STATE OF RHODE ISLAND AND PROVIDENCE PLANTATION
DEPARTMENT OF TRANSPORTATION
RHODE ISLAND CONTRACT NO.2012-CH-010
FEDERAL-AID PROJECT NO. FAP Nos: HPP-4868(002)

Northwest Bike Trail / Woonasquatucket River Bikeway C-4

NOTICE TO PROSPECTIVE BIDDERS

ADDENDUM NO. 2 Prospective bidders and all concerned are hereby notified of the following changes in the Plans, Specifications, Proposal and Distribution of Quantities for this contract. These changes shall be incorporated in the Plans, Specifications, Proposal and Distribution of Quantities, and shall become an integral part of the Contract Documents.

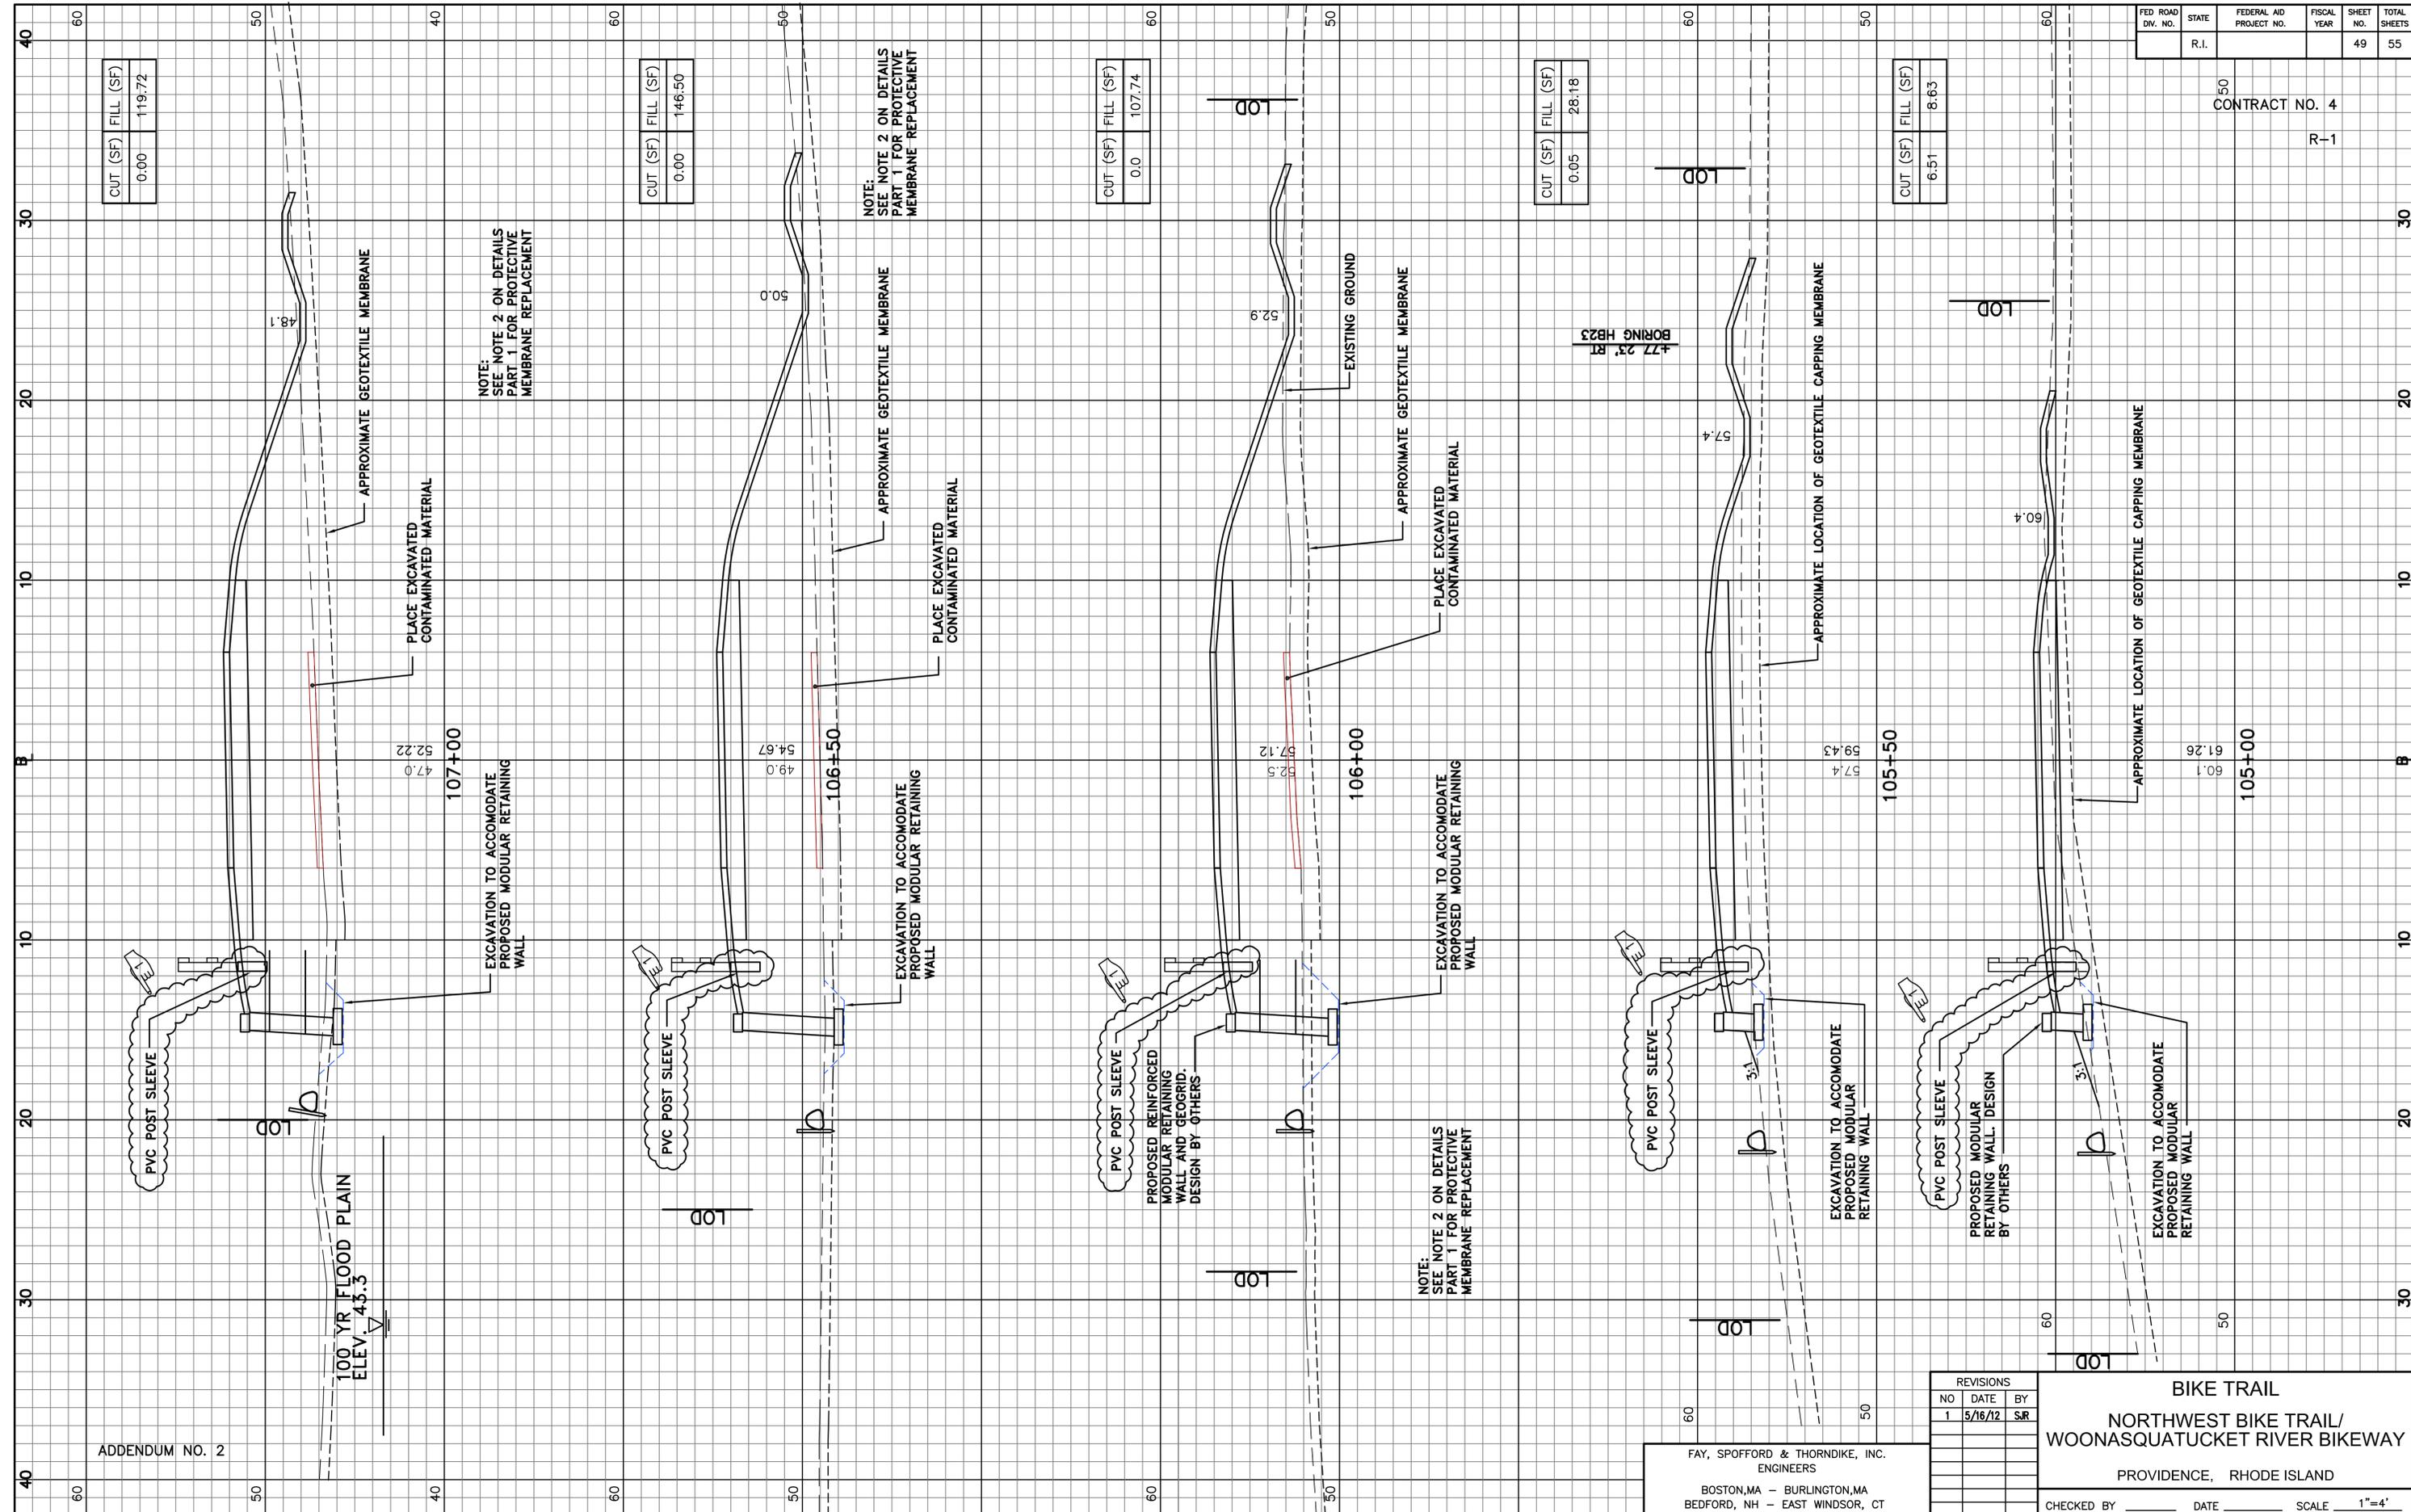
DELETE Cross Section, Sheet 49 of 55 in its entirety and REPLACE it with Sheet 49 of 55 (R-1) attached to this Addendum No. 2. Revised Concrete Post Sleeve to PVC Post Sleeve.

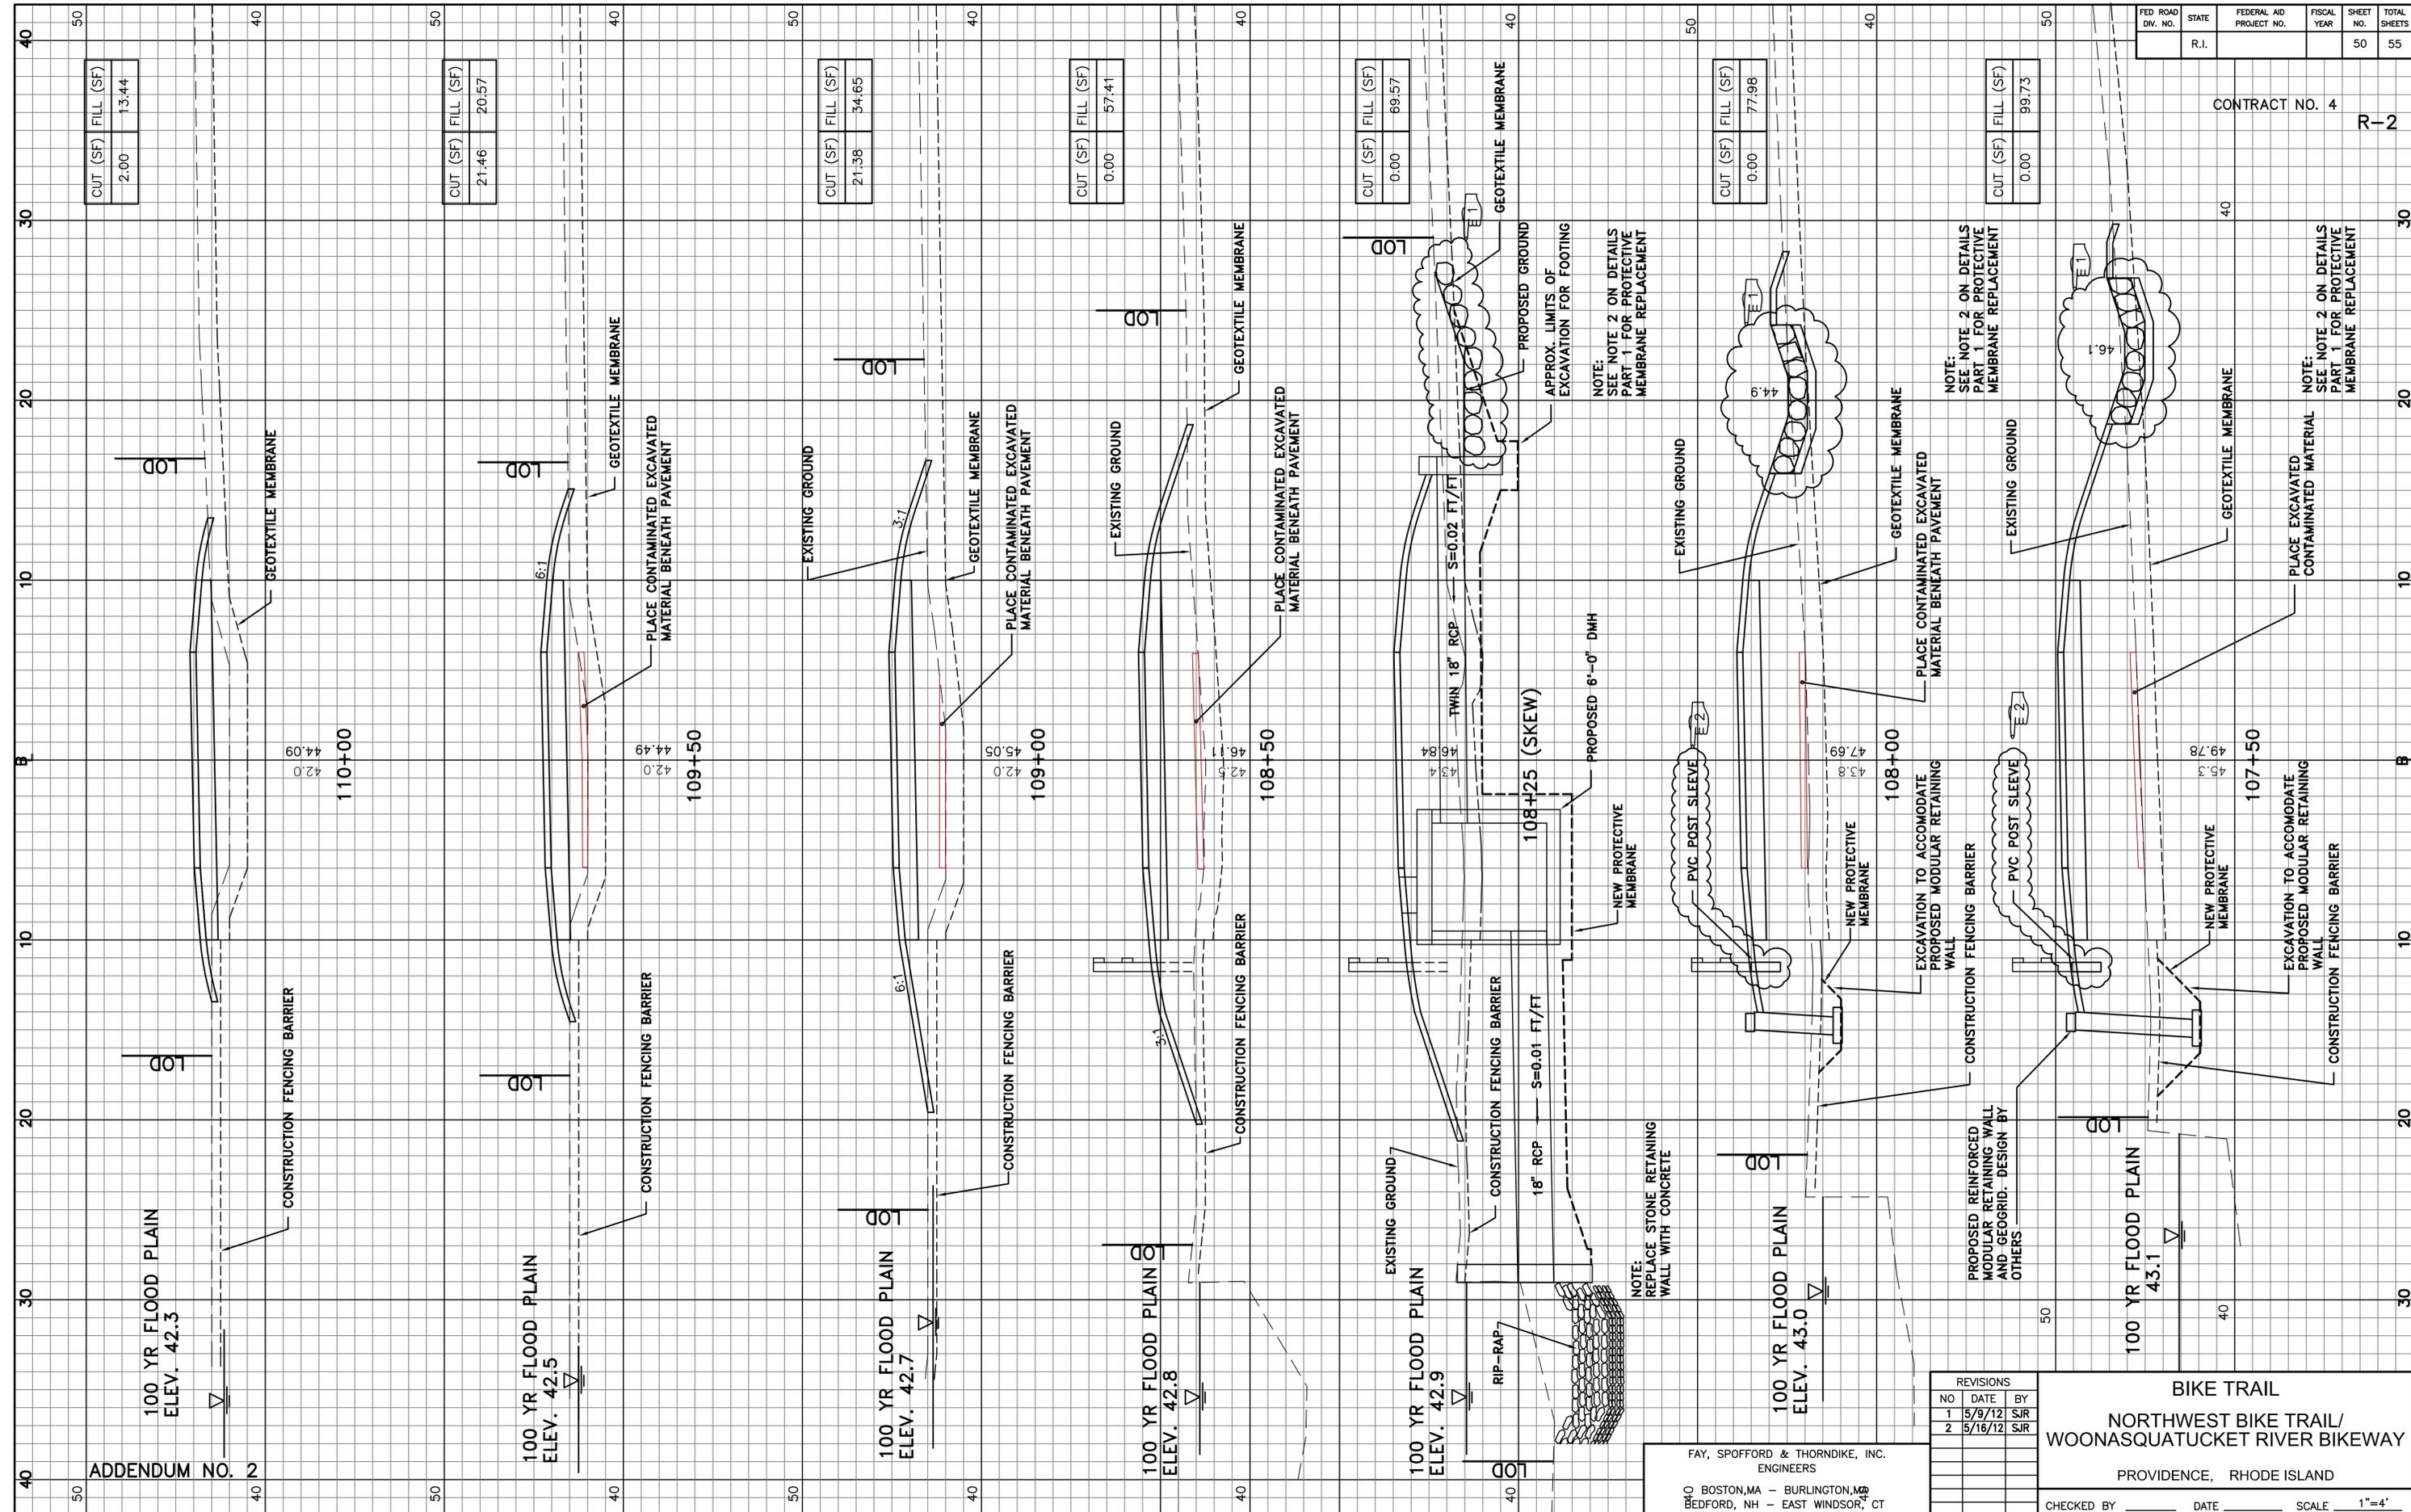
DELETE Cross Section, Sheet 50 of 55(R-1) in its entirety and REPLACE it with Sheet 50 of 55 (R-2) attached to this Addendum No. 2. Revised Concrete Post Sleeve to PVC Post Sleeve.
